Keysford Barn

DESIGN AND ACCESS STATEMENT

April 2025

Internal east facing elevation

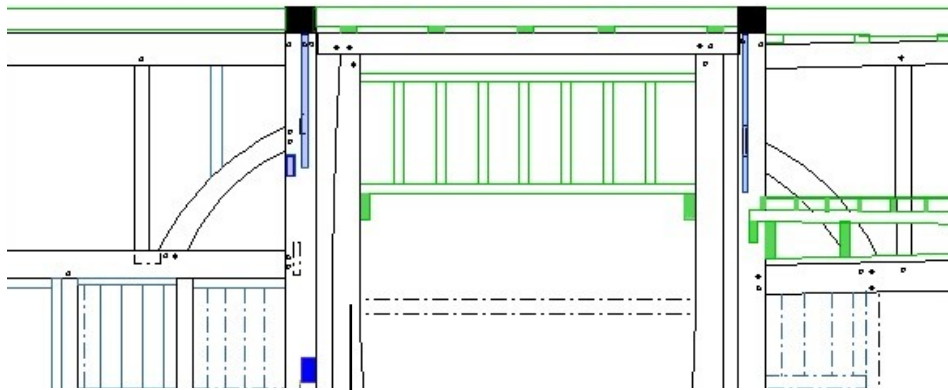
- Detail of the proposed glazing to the existing openings should be provided with a formal application. How does this relate to the existing fabric around the openings concerned? How does it relate to features of interest around these openings such as latches, or the grooved timbers adjacent to the barn doors which originally held boards to contain grain on the threshing floor? How are the retained solid timber doors to relate to the internal glazing? All of this should form part of a more detailed proposal, based also on the findings of the above mentioned historic building assessment.
[Noted and if approved we would anticipate this level of detailing forming part of the conditions as part of the planning decision.](#)

Retain timber mullions above barn door. We would like to propose a fixed glazed window to over-sail the historic mullions to allow more light into the space.

Retain timber slides to help retain historic narrative. As the external wall will become thicker during its thermal upgrade we hope the window frame will sit in front of this detail and to enable it to remain internal.

Retain 'makeshift mullion window' to and ovolo moulding to retain the expose the character and evolution of the building. Allow for a timber framed casement window to sit in front of the existing timber framing to allow for ventilation into the new space.

Thermal Upgrades

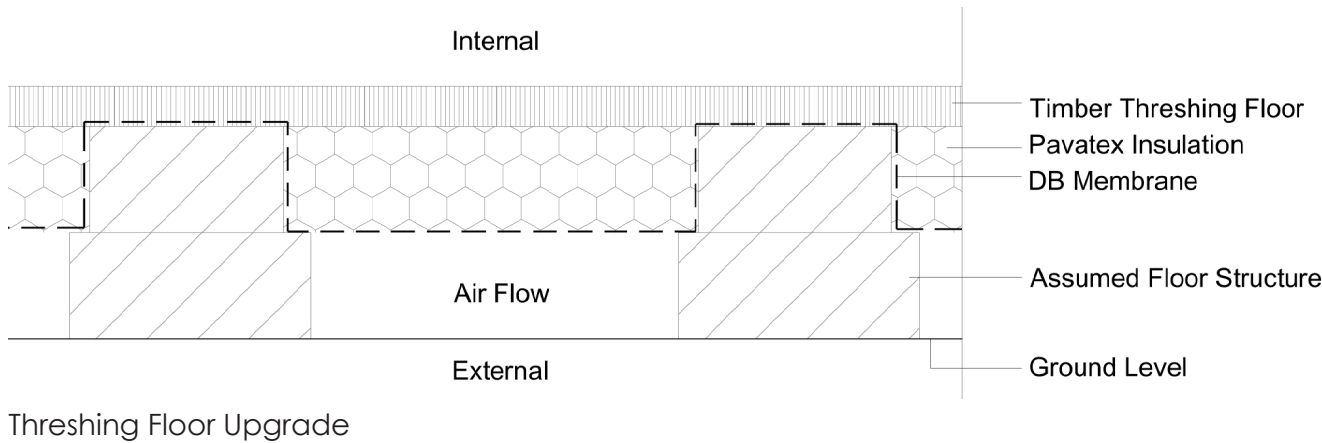
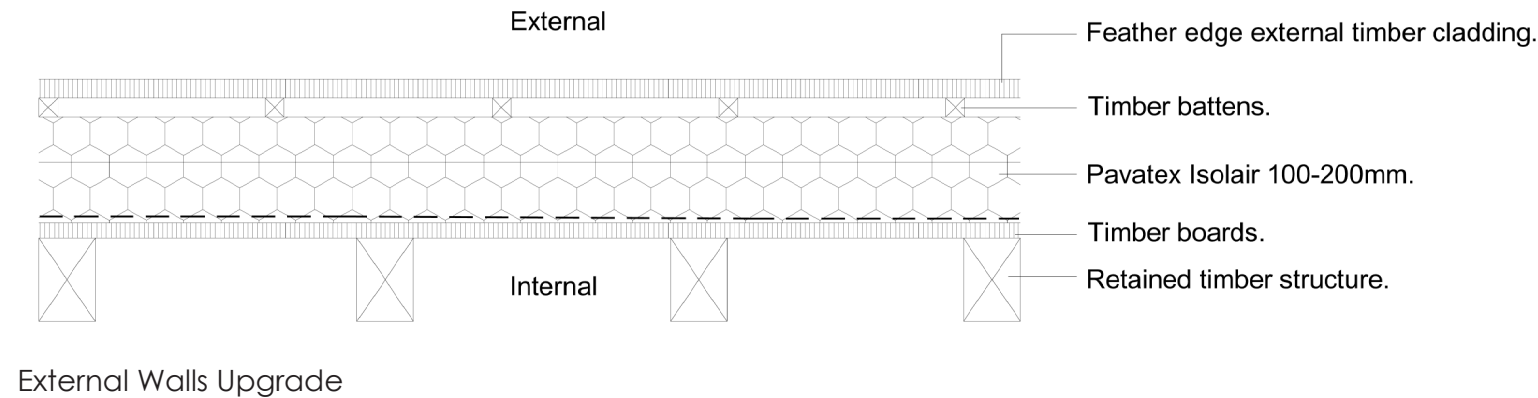
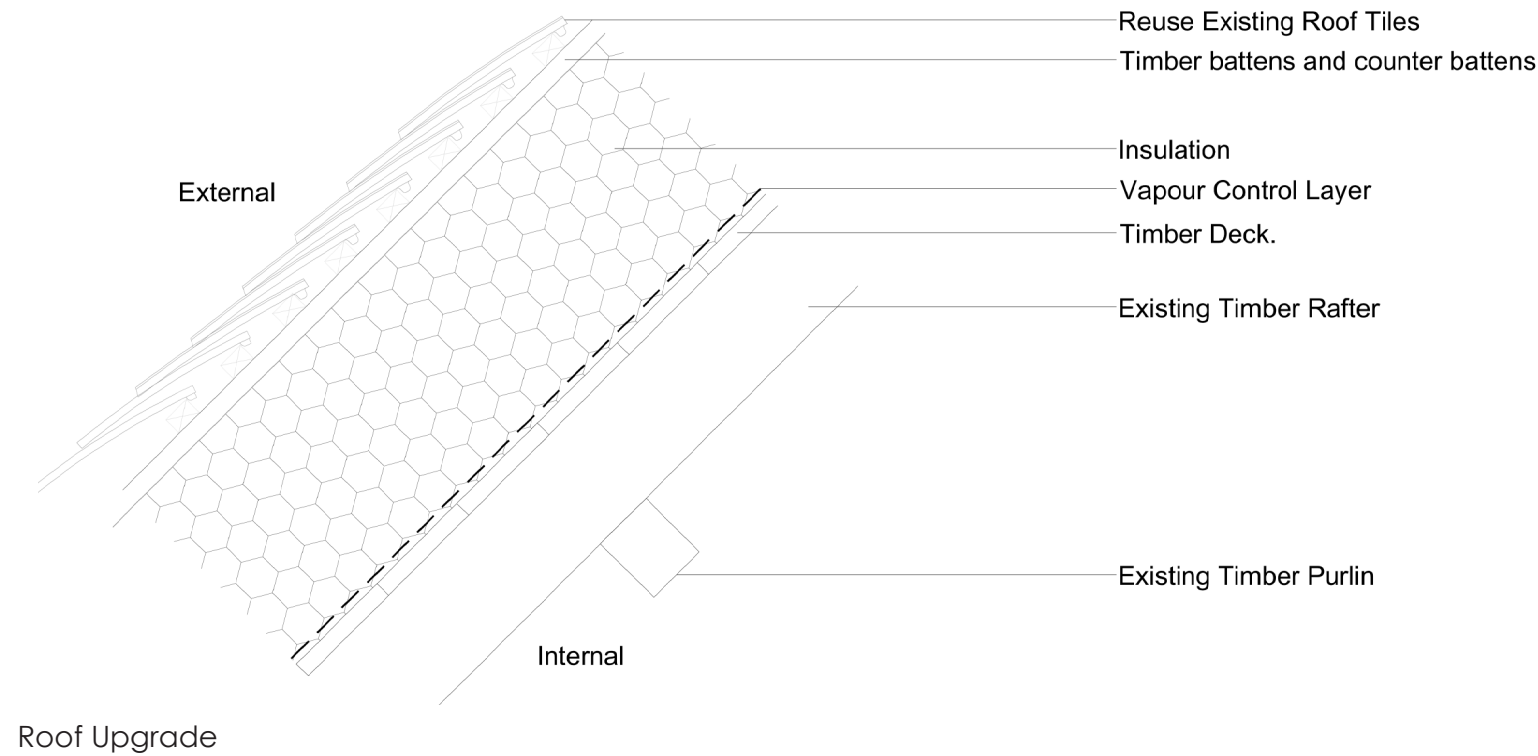
- Any formal application should include typical detail of the manner in which it is proposed to introduce insulation to walls, roof and floor of the building. This should be detailed with a view to retaining fabric and features of interest- for example the timber framing to the walls and roof of the building should remain exposed to view, as this is such a key component of the character of the building. Likewise the introduction of insulation beneath existing historic flooring will require careful consideration. Given the importance of this to the practicality of the scheme and its acceptability in listed building terms I would expect to see this detail as part of an application, rather than by condition.

Noted. We will have provided some ideas as how we would approach the upgrading of the floors, walls and roof and have indicated a thickness of 300mm to the external walls and as well as a raised ridge. With the hope of retaining the exposed timber frame internally.

In order to retain and expose the internal timber frame we must insulate the roof and walls externally. This will involve a deeper wall build up and a raised ridge. See details opposite and the proposed planning drawings for more detail.

Insulating the floor may prove trickier given the historic nature of the threshing floor. However in order to restore and make this barn usable it is important that we insulate the floor. We are proposing to carefully lift the threshing floor and insert a D3 membrane between the floor structure where the Pavatex insulation can sit and then relay the threshing floor on top.
